## ST. TAMMANY PARISH

**Addendum No.:** 2

**Bid#:** 24-47-2

**Project Name:** River Oaks Building & Well Improvements

RIVER OAKS  
 BUILDING & WELL IMPROVEMENTS  
 PROJECT No.: TU23000160  
 RIVER OAKS DECK PLAN

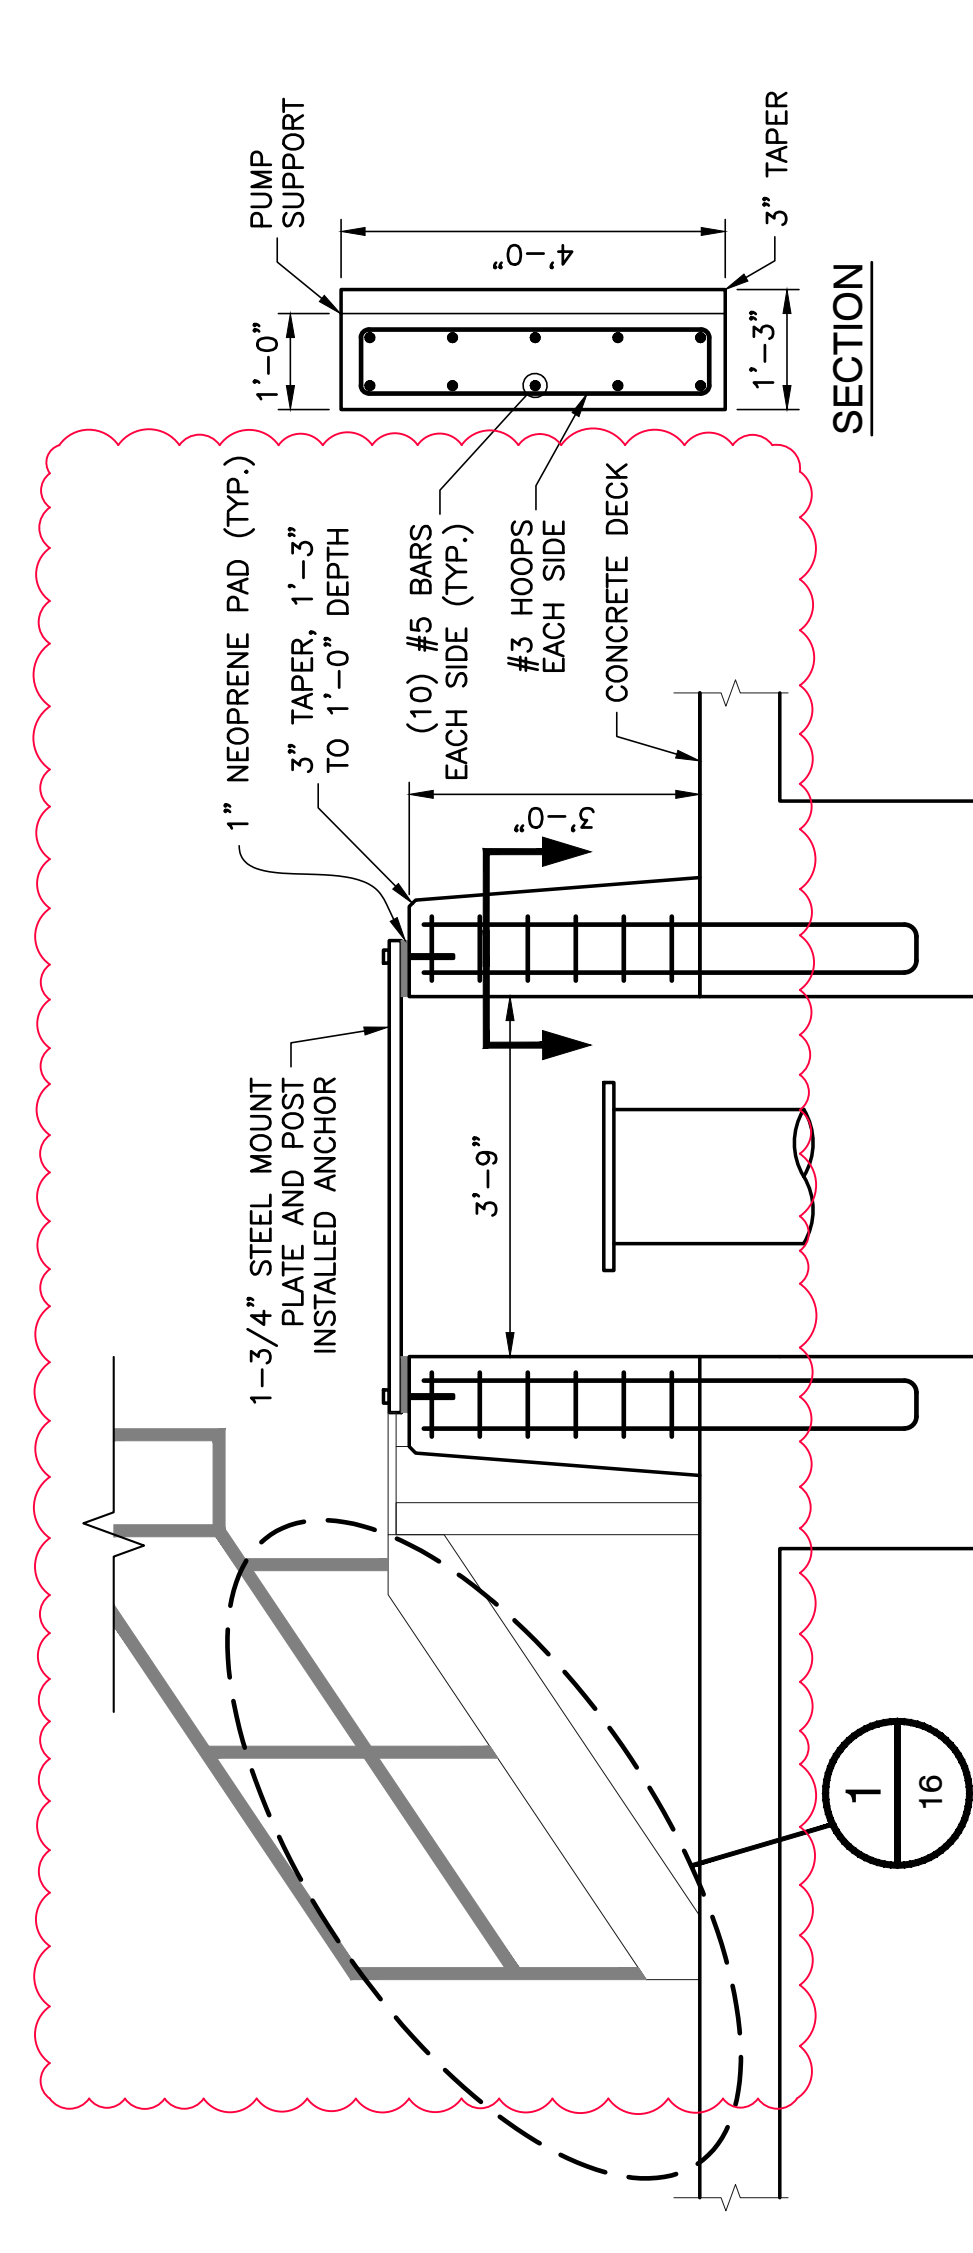
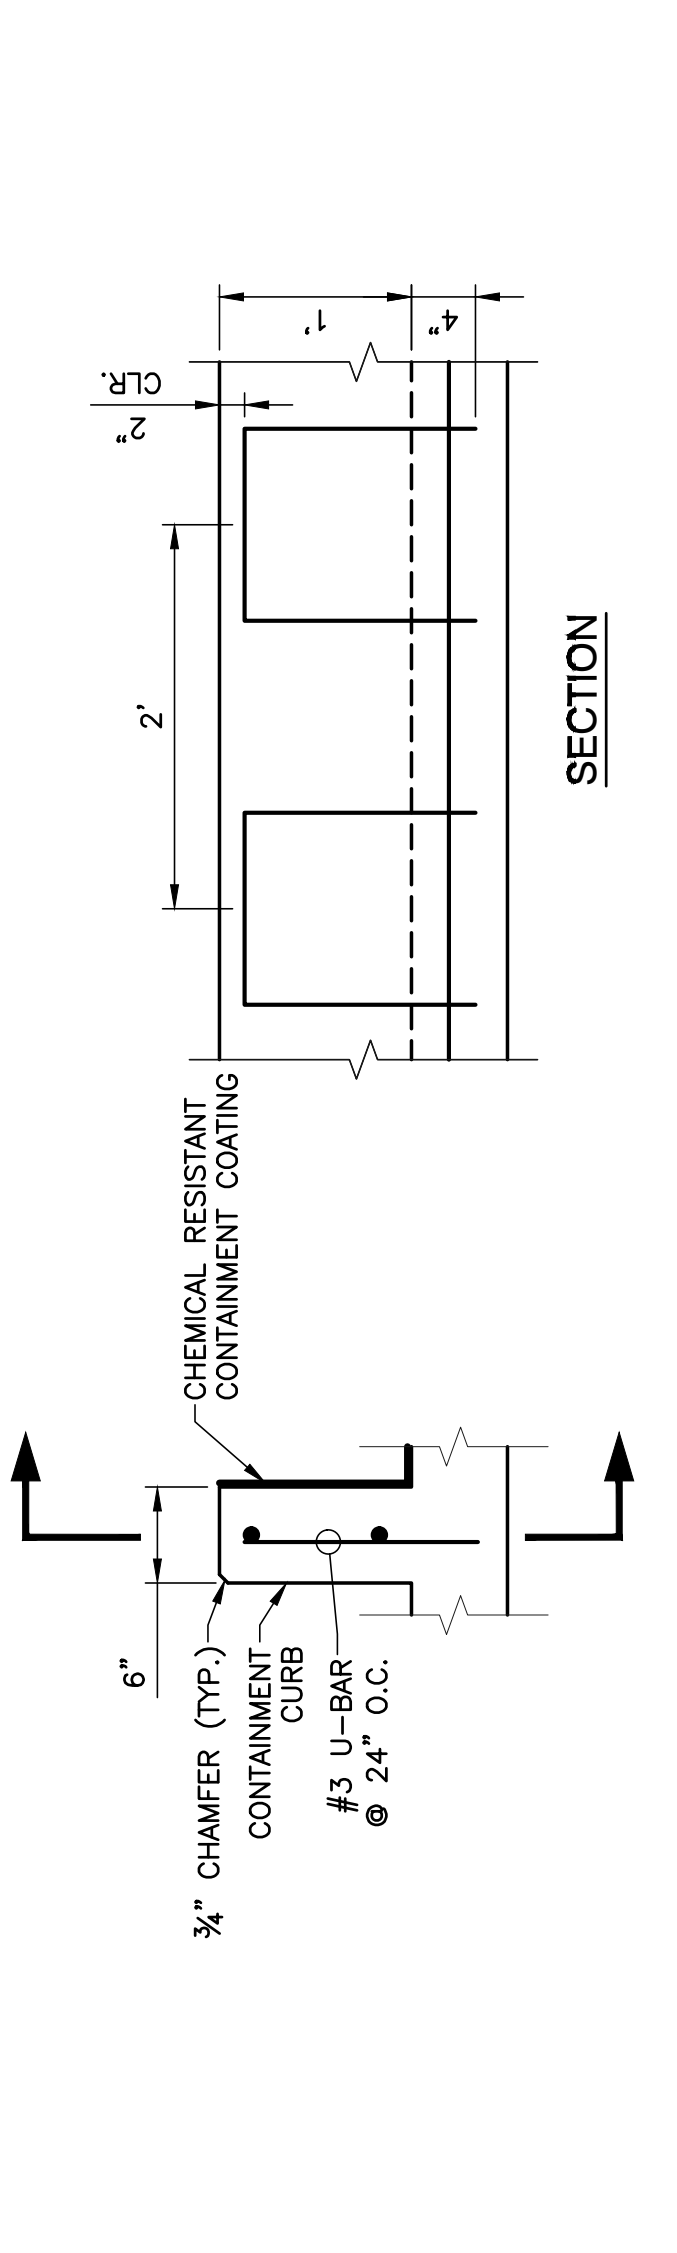
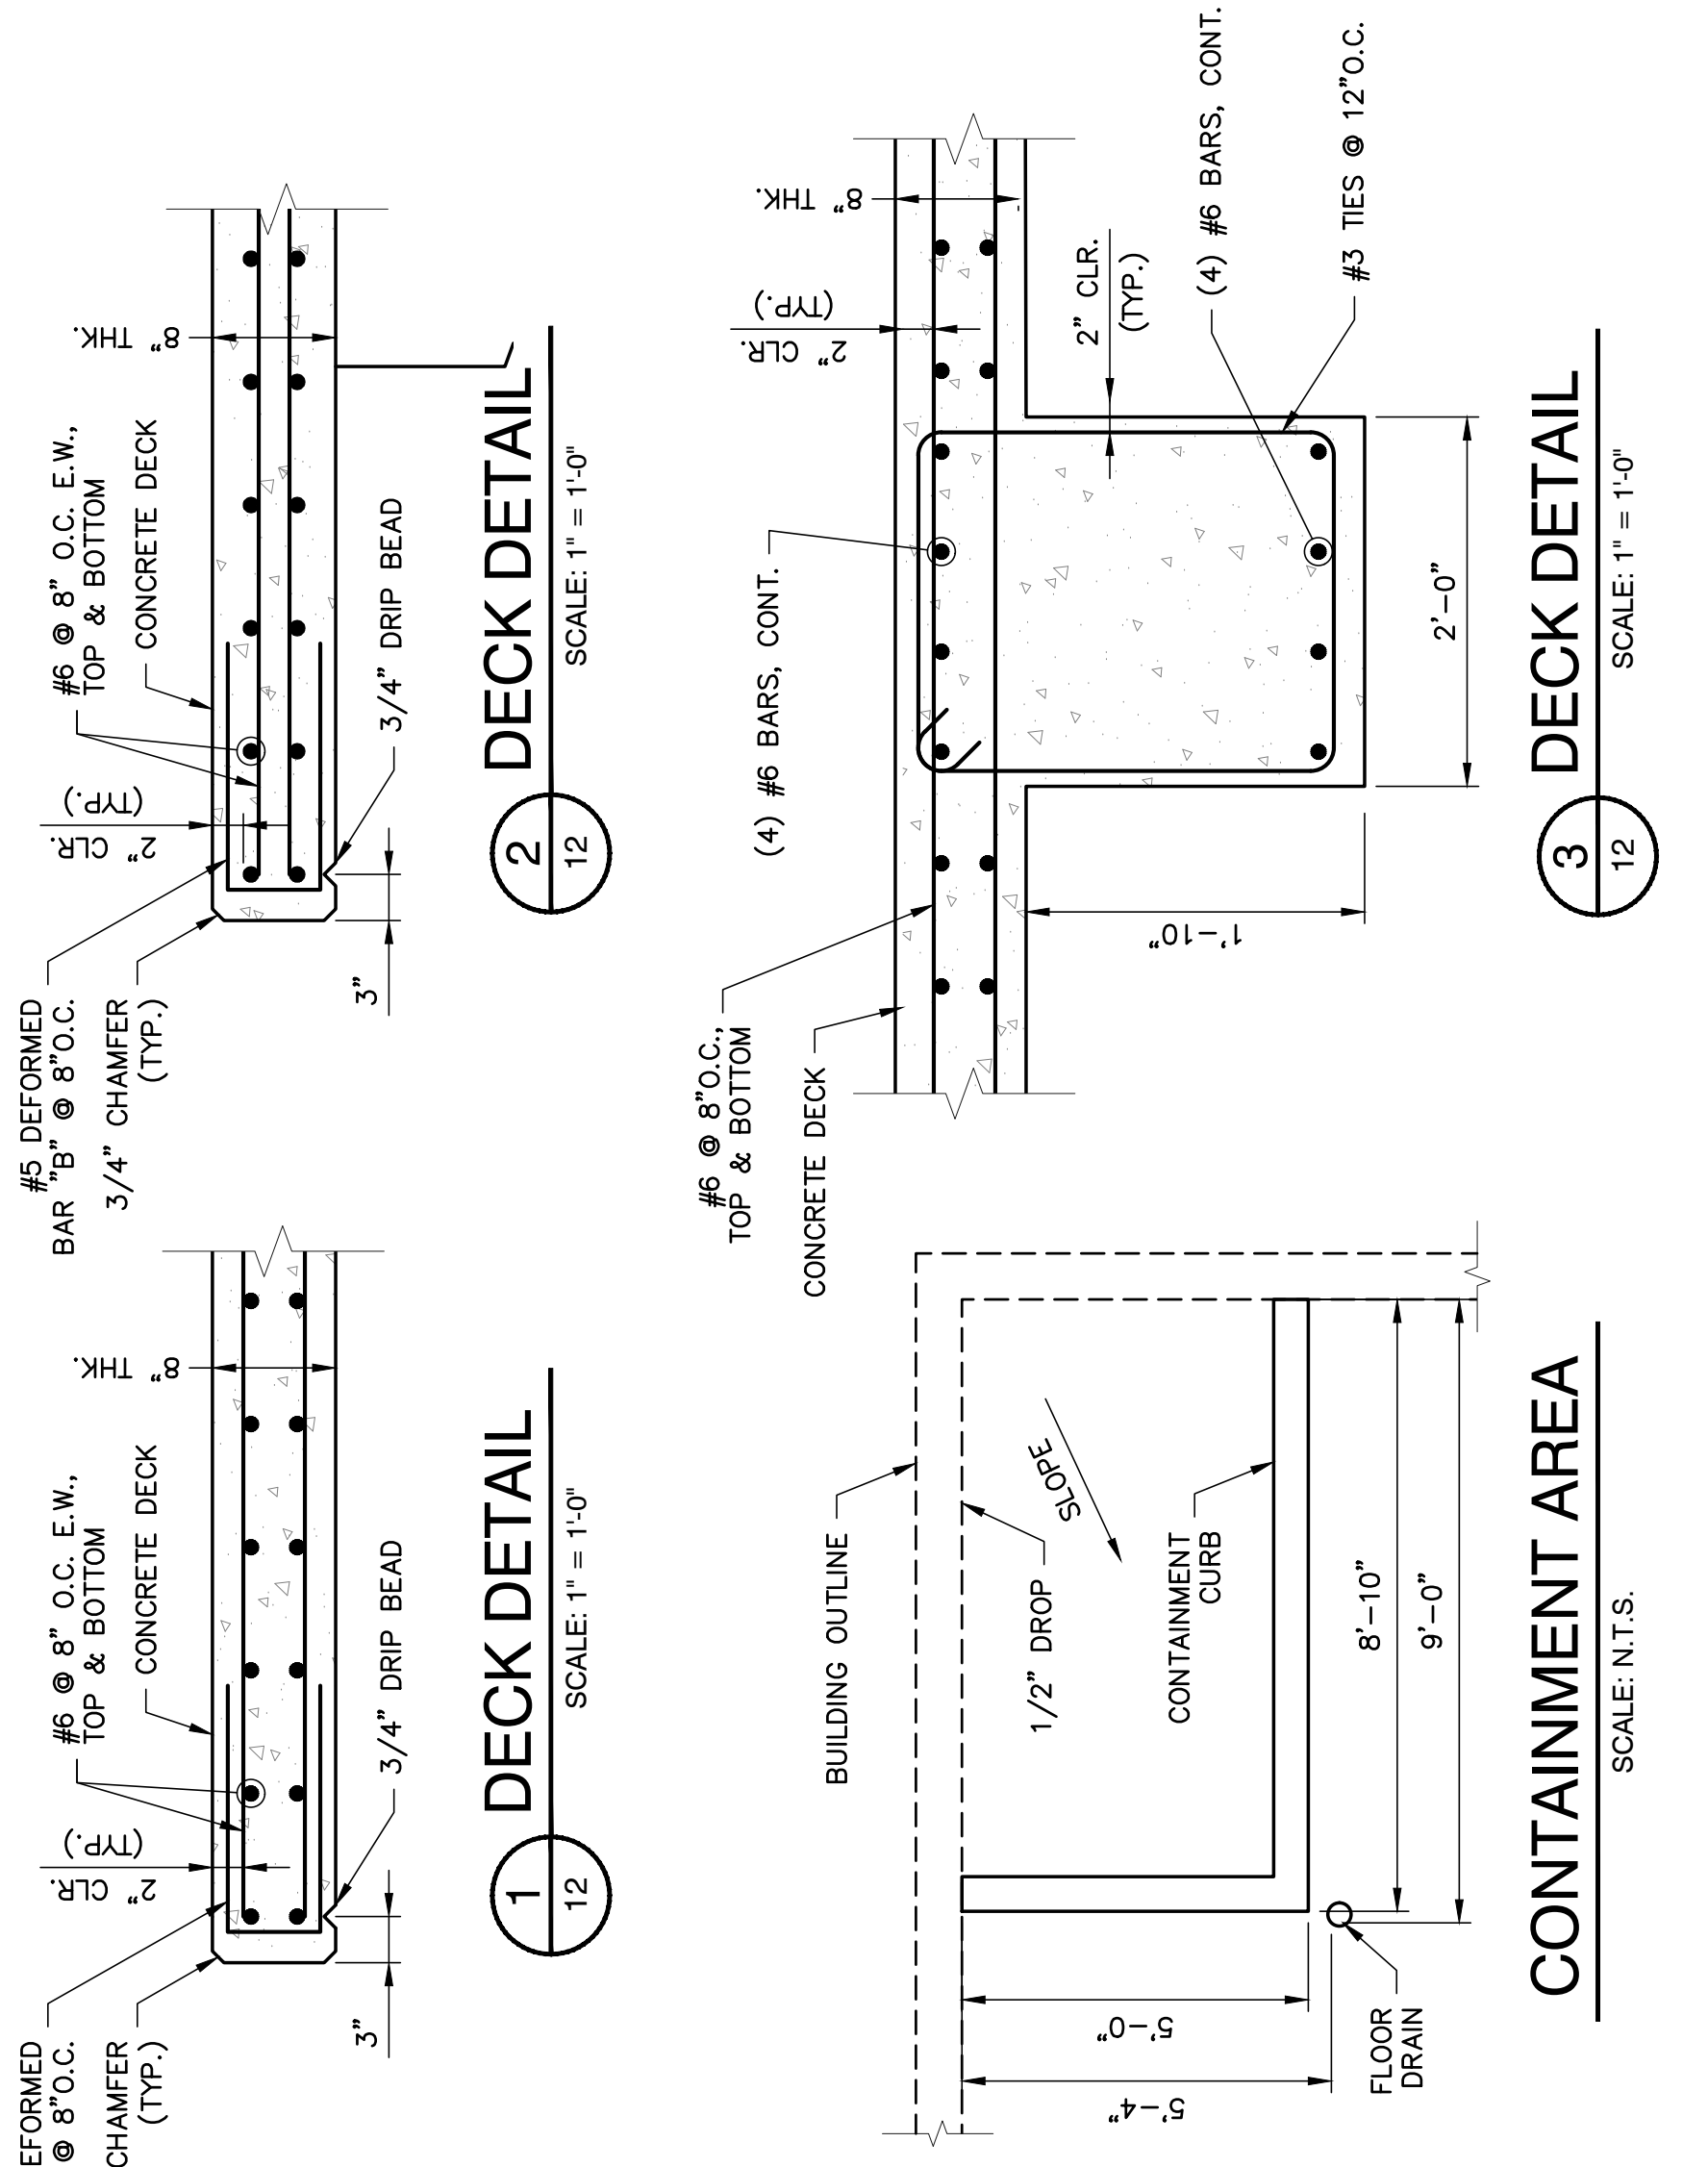
No.	DESCRIPTION OF REVISION	DATE
2	ADJUSTED ELEVATION OF WELL PEDESTAL	11.19.24
